North Little Rock Planning Commission
November 8, 2022 - Agenda / Public Hearing 4:00 PM
City Council Chambers – 300 Main Street, NLR, AR 72114

NLR Planning Commission - November 8, 2022

SHEET NO. 1

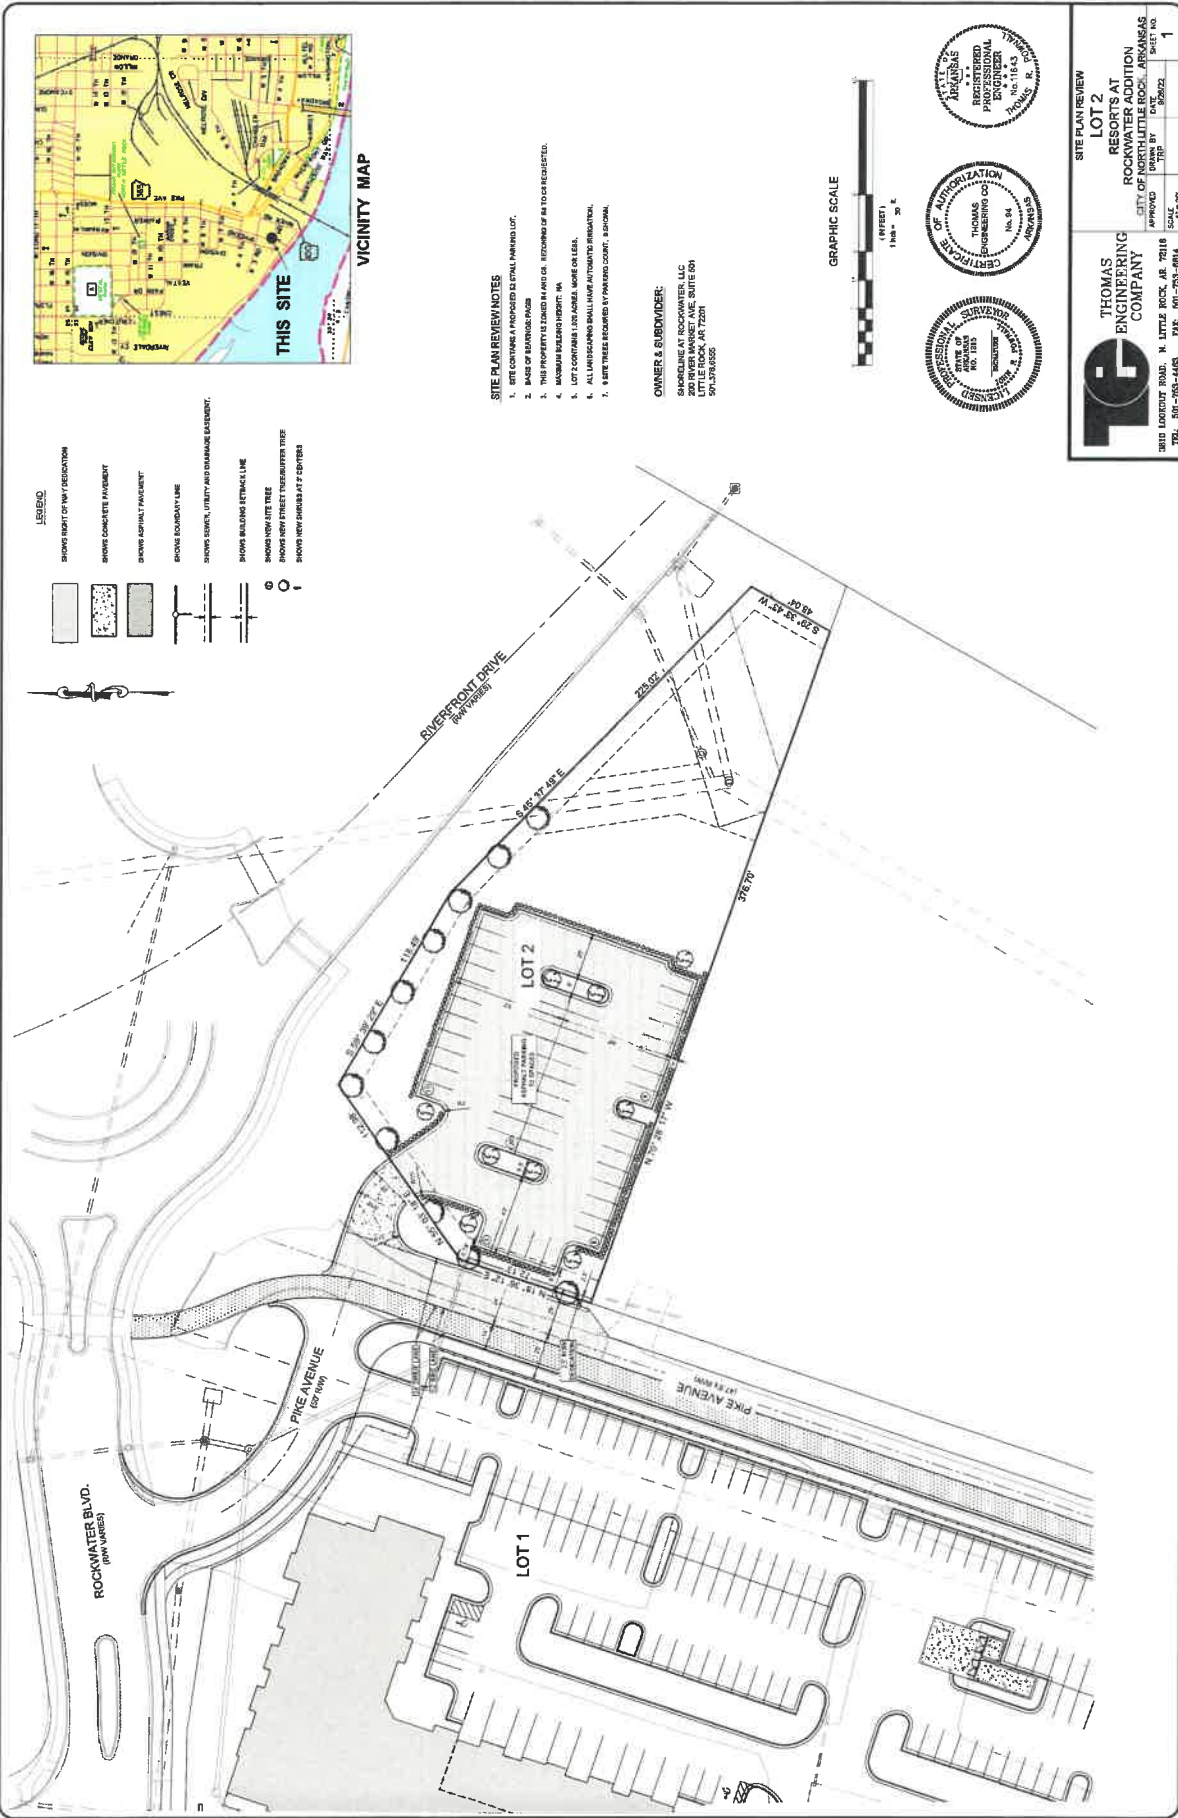
- a. Provide ½ street improvements (street, drainage, curb and gutter, sidewalk, streetlights) or a performance bond.
- b. Street improvements must be approved by City Engineer and accepted by City Council.

- a. Plat will be submitted to NLR Planning Department in CAD compatible DXF and/or DWG format, tied to Arkansas State Plane Coordinates.
- b. Provide 2.5' ROW dedication along Pike Ave.
- c. Provide 10' utility easements around property perimeter.

- a. Provide the standard requirements of Zoning and Development Regulations.
- b. If gated, gate to be set back 20' to allow stacking of 1 vehicle and to meet Fire Marshal requirements.
- c. All exterior lighting shall be shielded and not encroach onto neighboring properties.
- d. Provide the location of the "person-gate" entrance into the apartment development located on the west side of Pike Ave.
- e. Provide a striped pedestrian crosswalk from the parking lot to the "person-gated" entrance to the apartment complex.
- f. Provide trash receptacles within the proposed parking lot area.

- a. Provide 5' sidewalks and ramps with a minimum of 5' green space between sidewalks and curb to ADA standards and City standards.
- b. Provide ½ street improvements.
- c. Provide ROW dedication (2.5') along Pike Ave.
- d. Connect the bike path from Pike Ave to River Trail.

- c. Provide 4-street trees along Riverfront Drive.
- d. Provide 4-street trees along Rockwater Blvd.
- e. Provide 3-street trees along Pike Ave.
- f. Provide 9-parking lot shade trees. Parking lot shade trees must be located within the parking lot or a maximum distance of 10' from the edge of the parking lot.
- g. Provide a continuous screen of shrubs for any landscape strip adjacent to any parking area. Shrubs shall be 18" in height at planting and be planted a maximum 3' apart.
- h. Ground cover, grass, or mulch of shredded bark or stone shall be applied in all landscaped areas to reduce moisture loss and to improve the appearance of plantings near streets.
- i. Provide 6' front yard landscape strip between property line and paving.
- j. Provide 4' side yard landscape strip between property line and paving.

SITE PLAN REVIEW
LOT 8R, BLOCK 11
GILES ADDITION
NORTH LITTLE ROCK, ARKANSAS

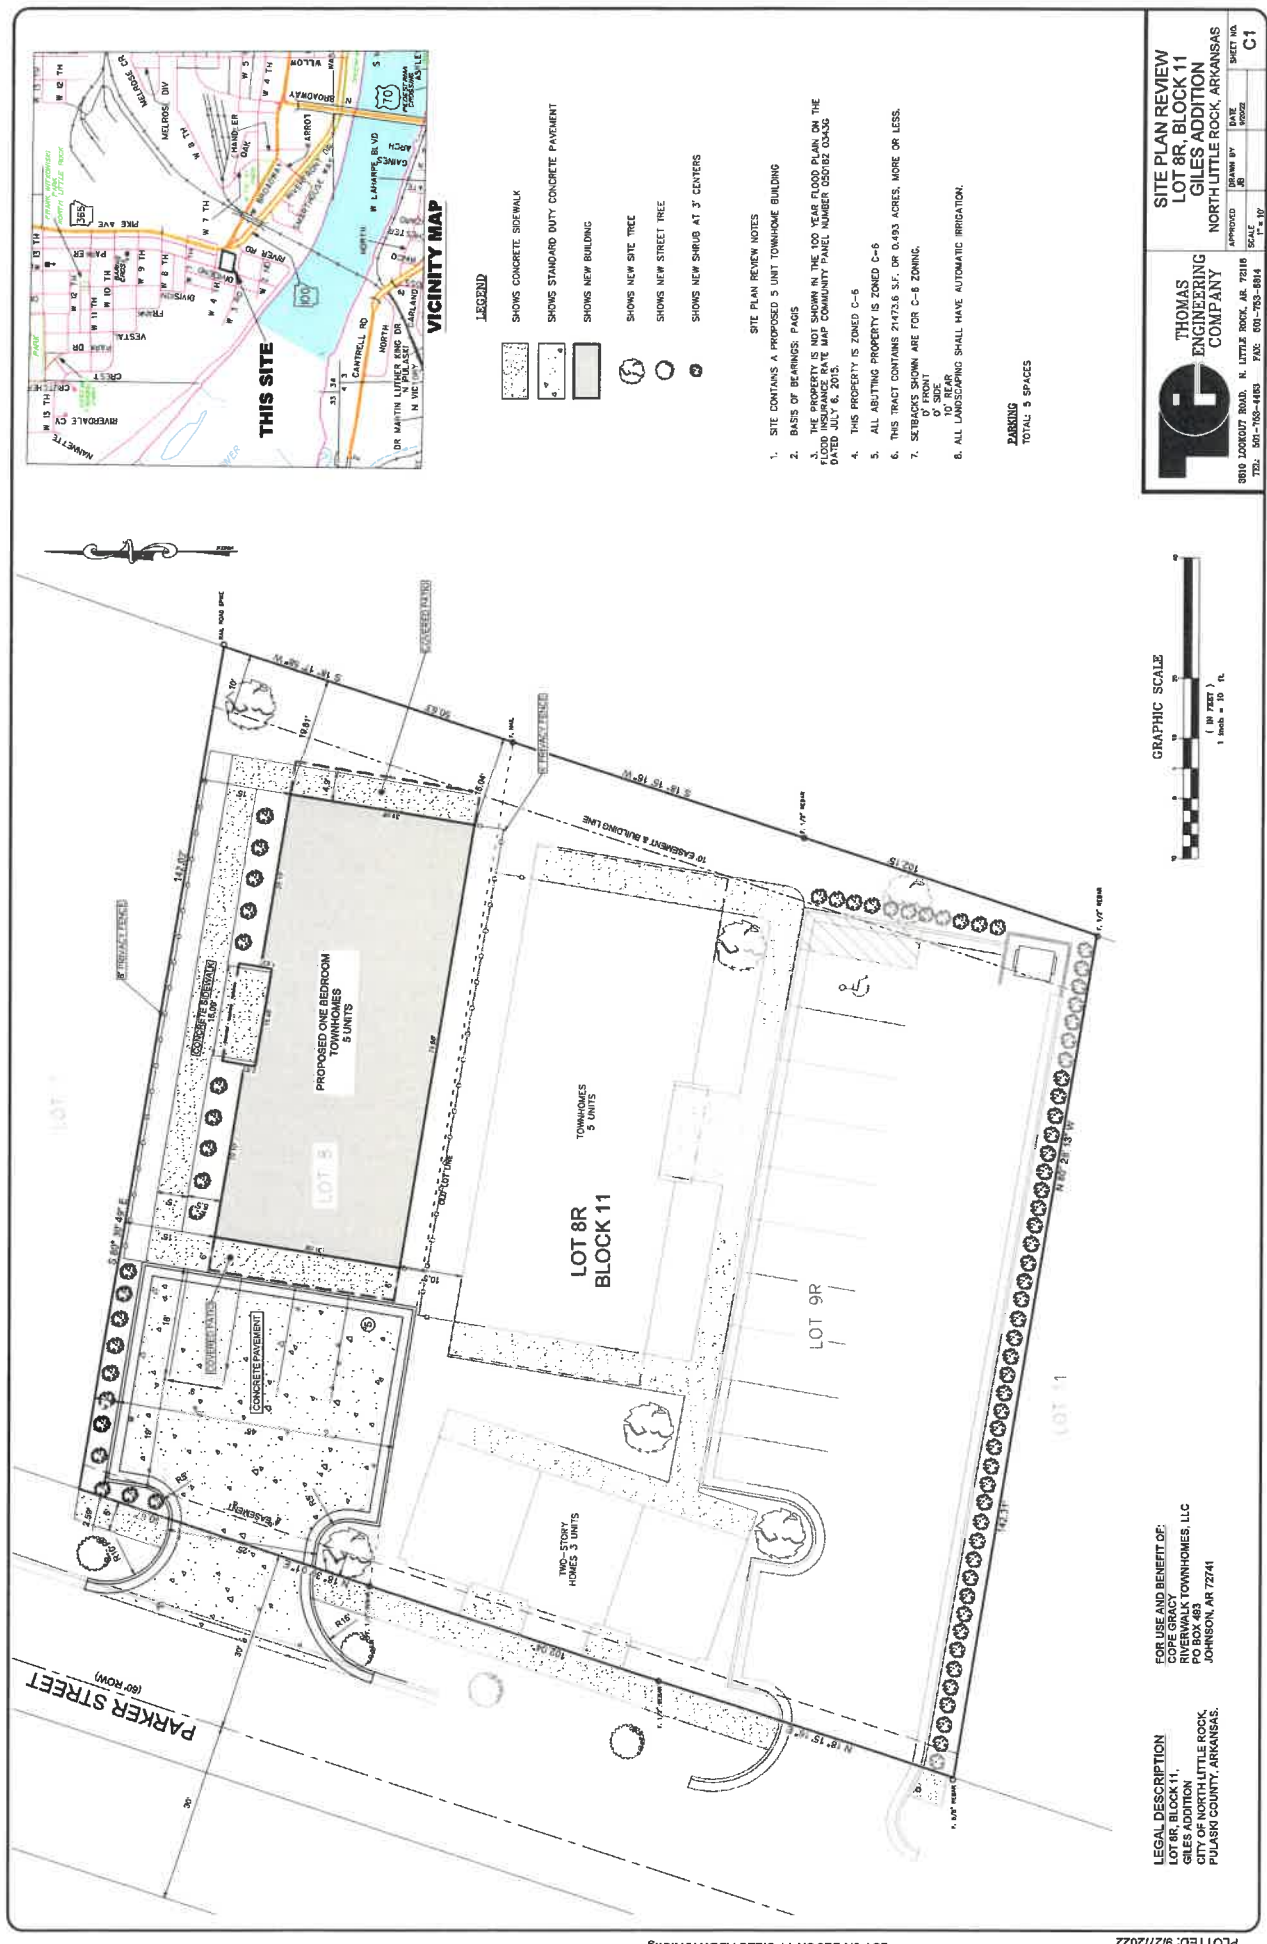
- 3. Permit requirements/approvals submitted before a building permit will be issued:**
 - a. A signed and recorded plat must be on file with the Planning Department.

- b. Provide CNLR Stormwater Permit application to City Engineer with half size erosion control plan showing silt fence, storm inlet protection, and drainage details.

- c. Provide CNLR driveway/curb cut permit application to City Engineer.
- 4. Planning requirements before the plat will be signed:**
 - a. Plat will be submitted to NLR Planning Department in CAD compatible DXF and/or DWG format, tied to Arkansas State Plane Coordinates.

- b. Provide street trees or provide a bond.
 - c. Provide streetlights or provide a bond.
 - d. Provide 10' utility easements around property perimeter.
